T ECHNICAL INFORMATION

98940

Subject ▶ Modification of Wheel cover, Bearing box and Housing set

For Models ▶ BGA402, BGA450, BGA452, GA4034, GA4534, GA5034

① BGA402 for Australia, New Zealand

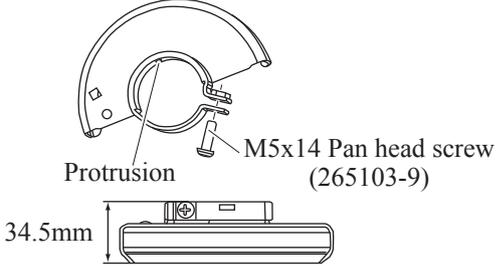
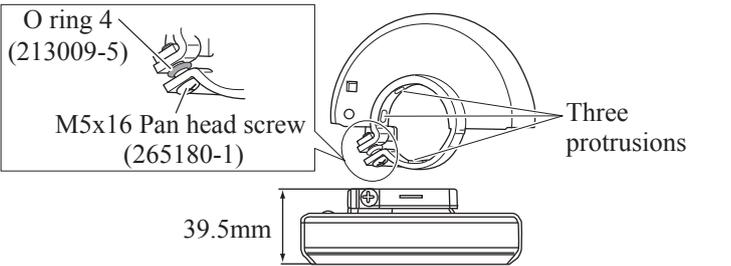
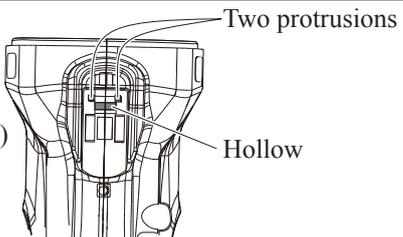
▶ Current	▶ New
<p>Wheel cover ass'y (135196-9) including M5x14 Pan head screw (265103-9)</p>  <p>Protrusion M5x14 Pan head screw (265103-9) 34.5mm</p>	<p>Wheel cover 100AK ass'y (125885-4) including O ring 4 (213009-5) and M5x16 Pan head screw (265180-1)</p>  <p>O ring 4 (213009-5) M5x16 Pan head screw (265180-1) Three protrusions 39.5mm</p>
<p>Bearing box (317819-3)</p>  <p>Depression</p>	<p>Bearing box (318331-6)</p>  <p>Three depressions</p>
<p>Housing set (188704-5)</p> 	<p>Housing set (188761-3)</p>  <p>Two protrusions Hollow</p>

② BGA450 for Australia and BGA452 for Australia, New Zealand

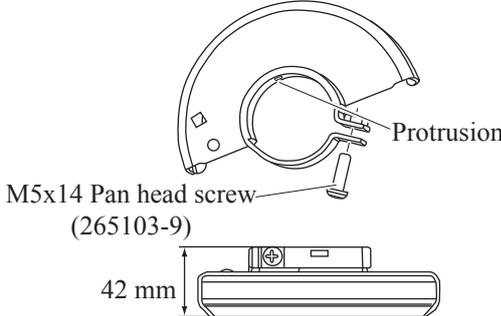
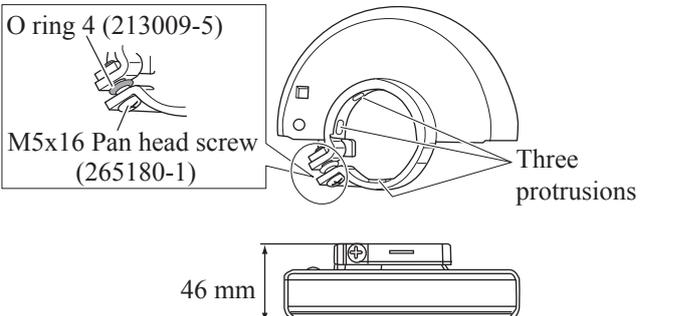
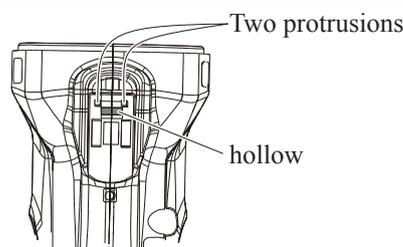
▶ Current	▶ New
<p>Wheel cover ass'y (125267-0) including M5x14 Pan head screw (265103-9)</p>  <p>Protrusion M5x14 Pan head screw (265103-9) 42 mm</p>	<p>Wheel cover 115AK ass'y (123098-1) including O ring 4 (213009-5) and M5x16 Pan head screw (265180-1)</p>  <p>O ring 4 (213009-5) M5x16 Pan head screw (265180-1) Three protrusions 46 mm</p>
<p>Bearing box (317819-3)</p>  <p>Depression</p>	<p>Bearing box (318331-6)</p>  <p>Three depressions</p>
<p>Housing set (for BGA450: 188703-7) (for BGA452: 188704-5)</p> 	<p>Housing set (for BGA450: 188762-1) (for BGA452: 188761-3)</p>  <p>Two protrusions hollow</p>
